הנדון: מסמך שאלות ותשובות מכרז פומבי בינלאומי מס' 14/2019 לתכנון ובניה של אתר משקף המכולות החדש בנמל המפרץ בחיפה ולייצור, אספקה והתקנת מערכת שיקוף מכולות ותת מערכות ולתחזוקתן לתקופה של עד 10 שנים מתום שנת האחריות בשיטת "עד המפתח" TKP

שאלות ותשובות-
חיפה, נמל המפרץ.

I.T.A (Israel Tax Authority)
International Public Tender No. 14/2019
Design & Construction of Customs Radiographic Site
Haifa Bay Port

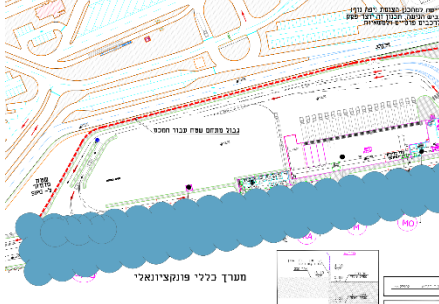
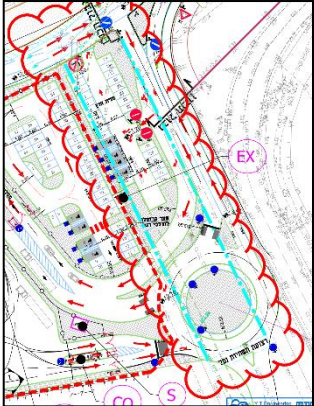
46	SOW SECTION 6 G	5.5.4.2.2	The LPR systems (about 12) will be installed at the following locations: • Entrance and Exit lanes for private cars (A few locations according to final site plan and Customs House location)	1. On the concept drawing provided in the tender, the entrance lanes in checkin and check out area are less than 6, please confirm the exact required amount of LPR.	Only the requirements written in the tender documents are obligating. The functional drawing isn't binding, It is for better understanding Yes, there is only one tunnel in Haifa

<ul style="list-style-type: none"> • Up to six (6) Entrances lanes at trucks check-in areas. • Up to six (6) Entrances lanes at trucks check-out areas. • Two (2) Entrances to the radiation tunnel 	<p>2. Please provide a LPR location drawing which can indicate clearly each position that the customer want the LPR to be installed.</p> <p>3. We understand, in Haifa, there will be only one entrance to the radiation tunnel, please confirm.</p>	
47	SOW SECTION 6 G	5.2.2.2	<p>Cargo data is acquired from the following sources:</p> <p>a. From customs computer – throughout the unique Inspection Number, defined at the check-in</p> <p>b. The document scanner.</p> <p>c. Manual entry at the check-in</p>	<p>Please clarify which kind of specified cargo information needs to be manually entered?</p>	<p>Customs declaration number.</p>
48	SOW SECTION 6 G	5.4	<p>Access Control subsystem - People</p>	<p>We understand that the “access control system for people” at the site is not required to be integrated with our SDMS system, please confirm.</p>	<p>לא. כניסת האנשים חייבת להיות מבוקרת בהתאם לדרישות במסמך הבטחון. הדרישה כוללת מבנה מבוקר לבדיקת נכנסים בהתאם לדרישות במסמך.</p> <p>No. People's entry must be controlled according to the requirements of the security document. The requirement includes a controlled building for checking incomers as written in the security document.</p>

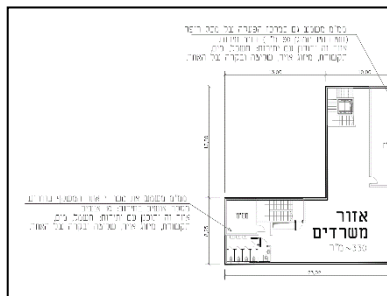
56	General question	General		Please confirm that there is no CIex, RAex, RB, RC, MOex in Haifa project.	<p>אין כאלו מבנים – ראה תוכנית B6 מהדורה 143-02-01-001</p> <p>There are no such buildings in this project – See plan 143-02-01-001 version B6.</p>
57	מערך פונקציונאלי 307459	Fence requirements		<p>1. In our understanding the work should include peripheral fence for the site according to the submitted specs. Please confirm.</p> <p>2. in addition, there is an internal fence between different areas in the site. Should this be according to the details of external fence?</p> <p>3. Please confirm that gates and barriers are part of project's scope.</p>	<p>1. yes 2. yes 3. yes</p>

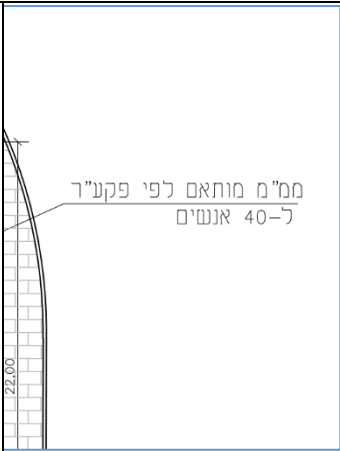
<p>3. Are the external parking places additional to the total of 140 in requirements from the Landlord or part of them? And should we aim to design for 140 private vehicles parking?</p> <p>4. Please confirm that the areas surrounded with light blue cracked line is a part of the site and should be part of the contractor's scope of work.</p> 	
62	SOW Section 6J	9	9. External Office (EX)	<p>1. What is the purpose of this office?</p>	<p>1- מטרת המשרד הינה מתן שירותים לקהלים שאינם נדרשים לאתר המשקף עצמו (דוגמת ימאים)</p>

<p>2. How many people will work there?</p> <p>3. Is there a need to provide any further other than a counter and a window?</p>	<p>The purpose of the office is to provide services to people who are not required to the site itself (such as seamen)</p> <p>2-המשרד איננו אמור להיות מאויש באופן קבוע אלא בשיטת "קיוסק" קרי, לפי קריאה בלבד.</p> <p>The office shouldn't be occupied regularly, but only by the KIOSK method.</p> <p>3-ברובם המכריע של המקרים יינתן שירות ע"י עובד/ת אחד</p> <p>In the majority of cases, service will be given by one employee.</p> <p>4-יש צורך בחלון מקשר בין נותן השירות למקבל, שולחן עבודה המאפשר 2 עמדות ישיבה ושתי עמדות מחשב על התשתיות הנדרשות לשם כך.</p> <p>There is a need for a window between the service provider and receiver, a desktop with two seating positions and two computer stations – with all the infrastructures required.</p> <p>5-מזגן, תאורה וכו' ע"פ הסטנדרט למשרד בגודל האמור.</p>

<p>Air conditioning, lighting etc. will be planned according to the standards for an office this size.</p> <p>6- במשרד החיצוני תותקן דלת מעבר לתוך אתר המשקף בלבד. הדלת תהיה מבוקרת. בסמוך למשרד החיצוני יותקן שער להולכי רגל בגדר. השער יהיה מבוקר, בד"כ סגור ומכוסה במערכות האבטחה שיותקנו על הגדר (טמ"ס). בנוסף לאמצעי הבקרה השער יהיה נעול בצילינדר ברמת רב בריח או שווה ערך ועם קפיץ מחזיר המיועד לעבודה "אאוטדור". בפתחת השער תתקבל התראה במוקד הביטחון</p> <p>השער ישמש את פקיד המכס המטפל בלקוח הנמצא מחוץ למשרד, בהתאם לצורך. השער לא ישמש למעבר הולכי רגל בשגרה.</p> <p>In the outer office a controlled doorway to the scanning site only will be installed. Next to the outer office a controlled pedestrian gate will be installed. The gate will usually be closed, locked and covered by the security systems on the fence. When opening the gate, an alert will be received in the security center. The customs officer that handles a client who stands outside the office will use the gate when needed. The gate will not be used for routine pedestrian crossing.</p>
